# INITIAL FIRE SAFETY INSPECTION REPORT

**Pacific Attires Limited**

**RSC ID: 26242**

**Date: 19 & 20-May-2025**

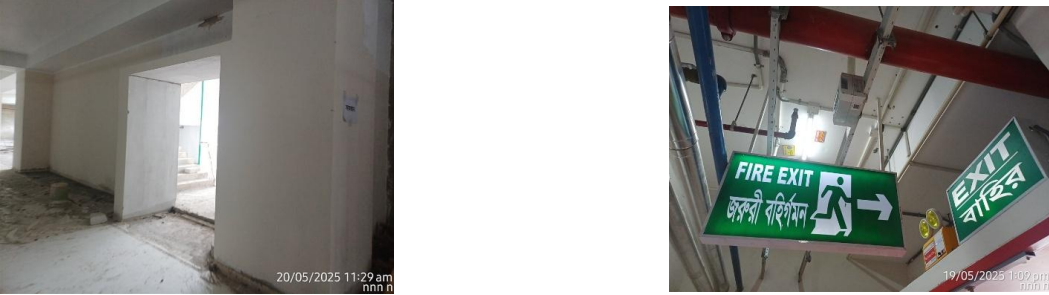
F-02	Means of Egress	<p>Handrails are not provided on both sides of each exit stairs-1, 2, 5, &amp; 6 on all floors. The installed handrails height on exit stairs-3 &amp; 4 exceeds more than 965 mm (38 in.) which is not as per standard.</p> <p><b>Location: Factory Building.</b></p>	<p>Provide handrails on both sides of the exit stair. New handrails shall have a minimum height of 865 mm (34 in.) and a maximum height of 965 mm (38 in.) as measured from the leading edge of the tread. Intermediate handrails shall be provided when the stair width exceeds 2.2 m (87 in.).</p> <p>Open guards shall have intermediate rails or pattern such that a sphere 200 mm (8 in.) in diameter cannot pass through any opening up to a height of 865 mm (34 in.). Handrail shall construct in accordance with RSC Technical Guidelines (Standard)<sup>1</sup> V1.0 Section 6.12.</p>	Within 3 Months
------	-----------------	---	--	-----------------

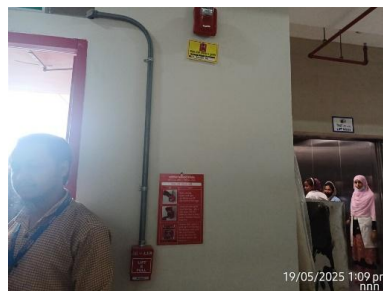
F-30	Fire Alarm & Detection System (FADS)	<p>The factory is installing a fire alarm and detection system that requires a detailed review to confirm compliance with NFPA 72 and RSC Technical Guidelines (Standard).</p> <p><b>Location: All Buildings.</b></p>	<p>Submit the fire alarm and detection system design to RSC for review.</p> <p>Once the design is reviewed, install and modify the fire detection and alarm system throughout the building in accordance with review comment, RSC Technical Guidelines (Standard) and NFPA 72.</p> <p>After installation the owner shall conduct internal testing and commissioning and then contact the RSC for witness of final acceptance testing.</p>	<p>Design within 2 Months and Modification/ Installation within 4 Months</p>
------	--------------------------------------	---	---	--
